VISIT TO THE CHURCH OF ST NICHOLAS, MAVESYN RIDWARE
17th AUGUST 2023

Church Electrical Installation

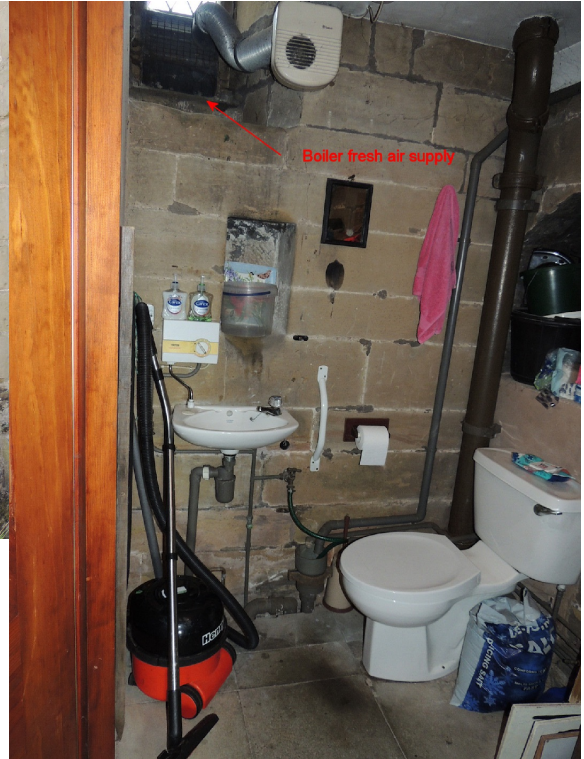
4. However there are several other issues that ought to be resolved.
5. There is a socket outlet over the sink in the kitchen. This must be protected by a 32mA RCD in the fuse board.
6. The MICC in the North Chapel has external corrosion and has very low impedance readings. This may cause problems in the near future, not least nuisance tripping of the main RCD. Therefore the parish ought to consider replacing this cable as soon as possible.
7. The socket outlet adjacent to the organ ought to be at low level.
8. The socket outlet ring circuit should be extended from adjacent to the organ across the chancel step to new socket outlets adjacent to the pulpit. Note that the pulpit light is supply via a 2 amp socket which does not have a fuse, this ought to be replaced by a 13 amp socket outlet and the plug top have a 2 amp fuse fitted for the light.
